**Commonwealth of Kentucky**

**Before the Public Service Commission**

Case No. 2011-00401

**Direct Testimony of  
Jeremy Fisher, Ph.D.**

15 **Figure 1. Cumulative present worth (CPW) of Options 1 (retrofit), 2 (NGCC replace in**  
16 **2016), and 4A (market purchase to 2020) under Company Base assumptions (left) and**  
17 **Synapse revised assumptions and corrections (right). See text for details.**

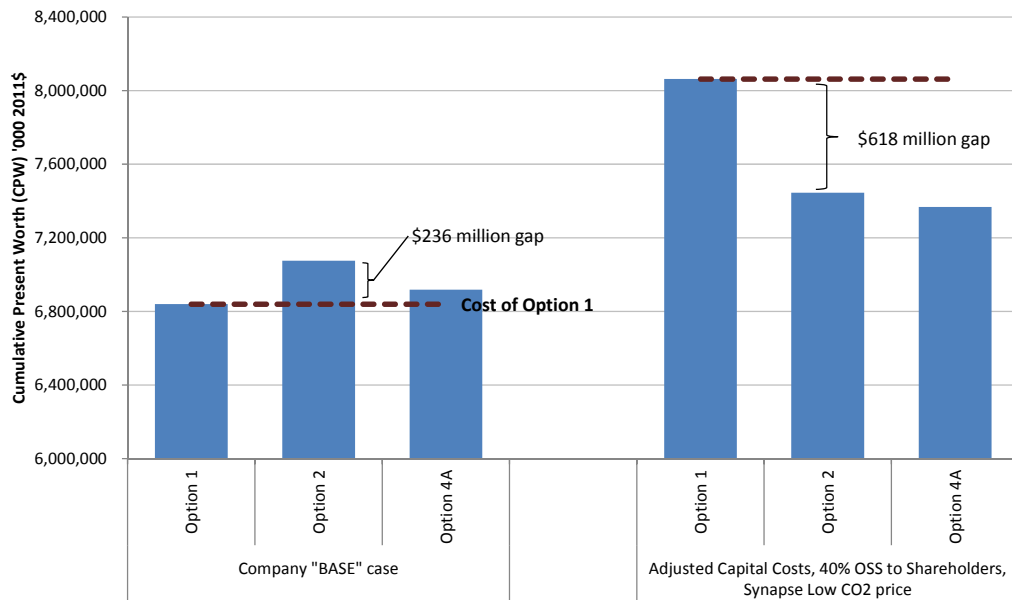
2 **A** When we correct knowable errors within the Company’s fundamental Strategist  
3 analysis, each and every alternative explored by the Company – repowering Big  
4 Sandy 1 as a natural gas unit, replacing the Big Sandy 2 unit with a brownfield  
5 NGCC, or purchasing market power to 2020 to 2025 – are all more cost-effective  
6 than the FGD retrofit by a wide margin.

7 **Figure 1** below (also **Exhibit JIF-2**) shows the total cumulative present worth  
8 (CPW) of Options 1, 2, & 4A under the Company’s “BASE” assumptions on the  
9 left, and the gap that appears to render Option 1 least cost of these three options.  
10 On the right, I show the results of our analysis after correcting the Company’s  
11 capital carrying costs, an allocation of off system sales (OSS) to shareholders, and  
12 running the model under a low-bound carbon dioxide cost (CO<sub>2</sub>) representative of  
13 that used by other utilities and organizations.

2 **Figure 2. Streams of carrying charges in Options 1 and 2.**

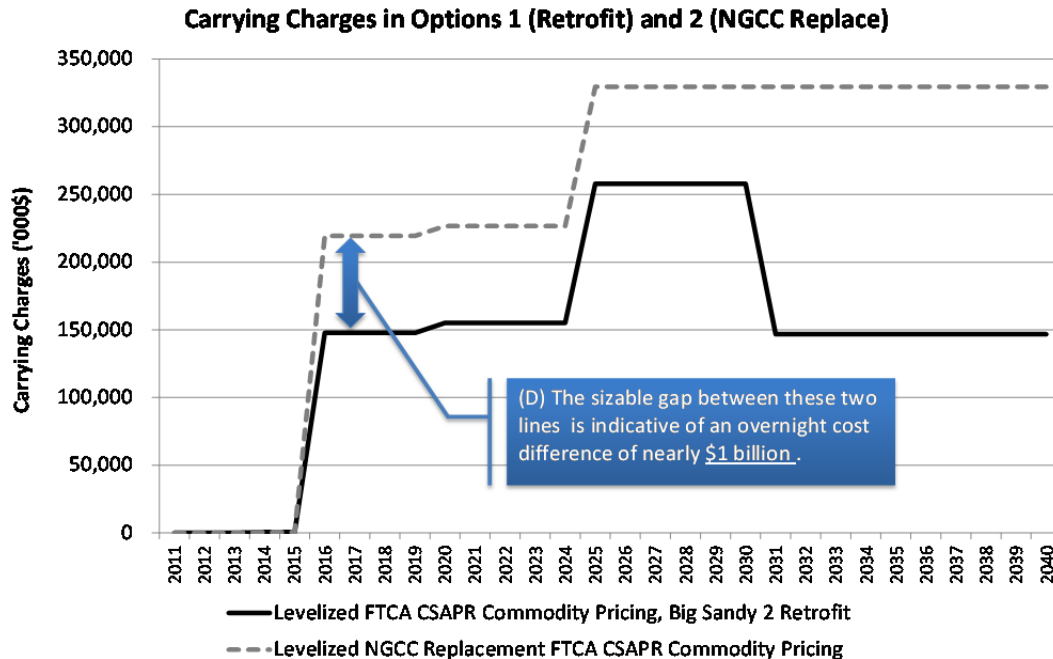
22 **A** I have looked closely at the stream of carrying charges that underlie the results in  
23 Exhibit SCW-4. Recalling that just about all other options are held constant  
24 between the Strategist runs, if we look at two sets of lines representing annual  
25 carrying charges between Option 1 (retrofit) and Option 2 (new NGCC) as in  
26 **Figure 2 (Exhibit JIF-5)**, below, we see that in 2016, the two lines both rise  
27 significantly and separate. In the Figure below, the solid black line is carrying  
28 charges of Option 1 – the Big Sandy 2 retrofit, and the grey dashed line is the  
29 carrying charges of Option 2 – the NGCC replacement.

3 The two projects represented by the costs from 2016 to about 2019 (when the next  
 4 capital cost is incurred) cost about \$784 million (the FGD) and \$1,057 million  
 5 (NGCC),<sup>17</sup> and have book lives of 15 years and 30 years, respectively. Taking the  
 6 expected annual payment of those two projects (not including AFUDC) over 15  
 7 and 30 years, we would expect the projects to have very similar carrying charges  
 8 (\$95 M and \$100 M, respectively).<sup>18</sup> Yet the Strategist modeling used a much  
 9 larger gap, as shown in Figure 1 above. In fact, the gap between the two lines  
 10 suggests a capital cost difference of nearly \$1 billion (2011\$).

5  
 6 **Figure 3. Total Capital Cost of FGD and replacement units, including AFUDC. Green bars**  
 7 **are derived from Weaver, Table 2 (p24); blue bars are derived from carrying costs in**  
 8 **Company Strategist Compilation Workbook.**

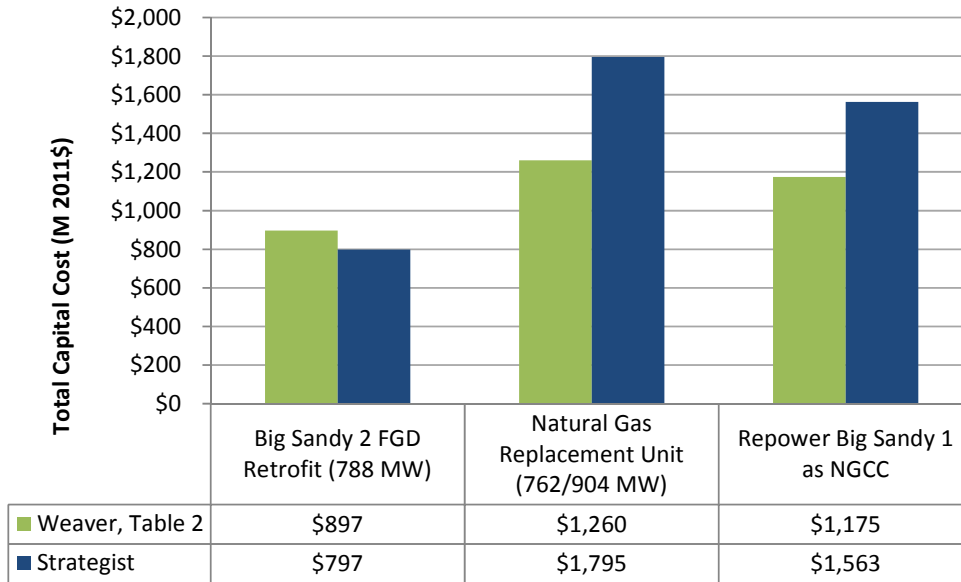
14 **A** Yes, but indirectly. The Company's analysis ceases being traceable in the "KPCO  
15 New Additions" spreadsheet – the Company only presents a string of potential  
16 levelized carrying charges for each potential start year. However, using the 2011  
17 potential levelized carrying charge as the equivalent of a non-inflated payment,  
18 I've estimated the capital associated with each project in the Company's planning  
19 horizon for KPCO. These values are in the second columns of the chart below,  
20 labeled "Strategist."

1 **Figure 3** (also **Exhibit JIF-6A**) shows my estimate of the 2011 capital costs with  
 2 AFUDC of the Big Sandy 2 FGD based on Weaver Table 2 (p24) and supporting  
 3 discovery, and the estimated 2011 capital costs used in the Company Strategist  
 4 Compilation Workbook (used to create Exhibit SCW-4).<sup>19</sup>

12  
 13 **Figure 4. Low, high and average CO<sub>2</sub> prices given by different utilities in IRP & CPCN from**  
 14 **2010-2011. The AEP forecast for this CPCN is the final bar on this chart.**

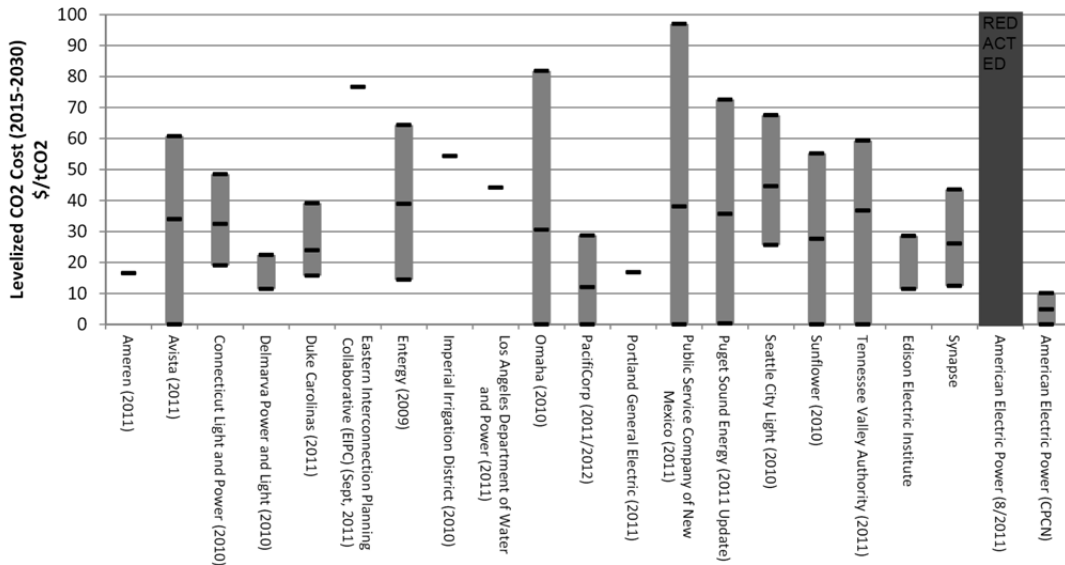
3 **A** I have charted the low, high, and (if multiple forecasts were given) average  
 4 levelized cost of CO<sub>2</sub> (2015-2030) from 16 utilities, Edison Electric Institute  
 5 (EEI), the Eastern Interconnect Planning Collaborative (EIPC) and forecast prices  
 6 from my firm Synapse, in the figure below (also attached as Exhibit **JIF-7D**).<sup>41</sup>  
 7 The reference case in this CPCN (the last column) is the lowest non-zero price  
 8 given and, aside from those utilities that only give a single value, just about the  
 9 narrowest range of prices as well. The AEP (8/2011) price that is second to last  
 10 represents the cost assumed by the utility in the preliminary analysis of Big Sandy  
 11 2 in August of 2011.

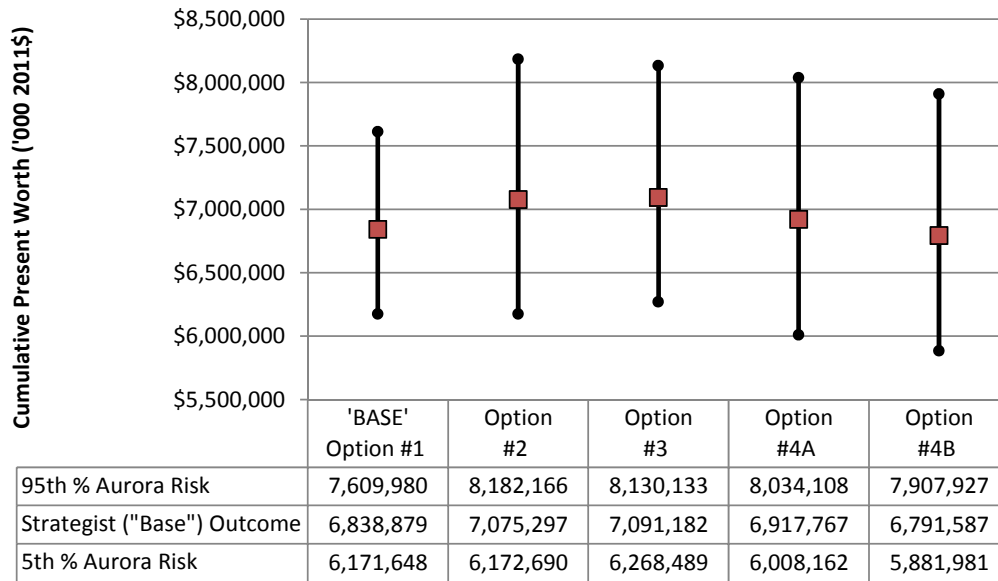
20 What Mr. Weaver does not state here is that while the Aurora model appears to  
21 show an apparent downside risk to natural gas purchases (market or steel-in-the-  
22 ground), the same results also show a large upside benefit as well– i.e. the model  
23 results would indicate that consumers have nearly as high a probability of coming  
24 out far better than far worse with a market replacement.

25 Indeed, simply drawing from the Company's data with no alterations to either  
26 Strategist or Aurora, we can re-cast the Strategist and Aurora results as the  
27 Company claims it intended. In **Figure 5** below (**Exhibit JIF-9**), I show the

15 I recommend that, if the Company chooses to pursue the use of the Aurora model  
16 for uncertainty analysis, that the Company withdraw Exhibit 5 and replace it with  
17 an exhibit (graphical, tabular or both) that correctly represents the uncertainty  
18 bounds and RRaR, rather than absolute outcomes as shown here.

1  
2 **Figure 6. Comparison of CPW cost components between Strategist and Aurora models.**  
3 Each pair of columns represents the total CPW of an Option as portrayed by either  
4 Strategist or Aurora. Working from the bottom up:

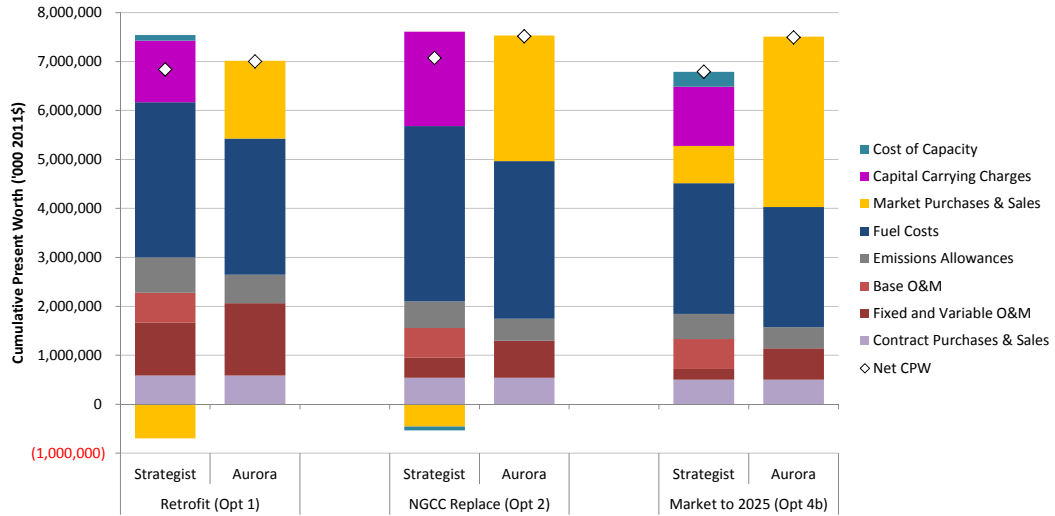
The similarities generally end with the name of the cost category. **Figure 6 (Exhibit JIF-11A)** below, shows the CPW (in ‘000 of 2011\$) of Options 1, 2, and 4b, broken down by cost category for both the Strategist (base case) and Aurora models (median solution). As will be detailed below, to the extent that these two models appear to result in *total* CPW that are even within range of each other may be no more than coincidence; the degree to which any differences between options can be examined at face value is suspect.

- Capital carrying charges do not appear to be represented in the Aurora model at all, meaning that important differences between the avoidable costs of construction (i.e. the FGD or replacement NGCC) and the uncertainty of those costs are not considered at all in this analysis.
- Market purchases are completely different between these two models, with Strategist predicting net market sales in Options 1-3, and Aurora predicting massive net market purchases in all cases. Figure 7 below (**Exhibit JIF-11B**) illustrates the massive discrepancies between market purchases in the Aurora and Strategist model, amounting to, for example a difference of over three billion dollars in Option 2 (NGCC replacement in 2015).

**Figure 7. Contrasting market purchases between the Aurora and Strategist models in three scenarios.**

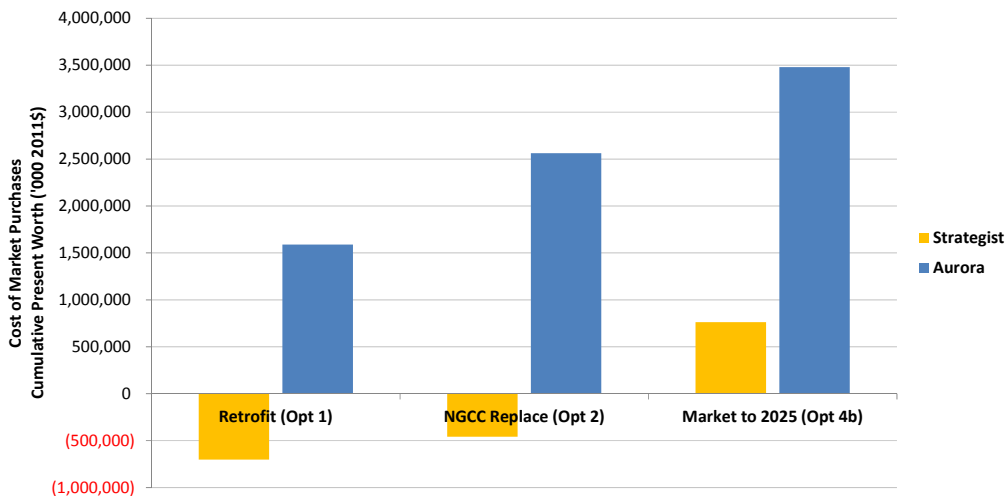
- Capacity purchases, while a smaller component of the overall CPW, appear to have a similar, but inverted, relationship between the two models. Strategist often predicts net capacity purchases and Aurora predicting net capacity sales.
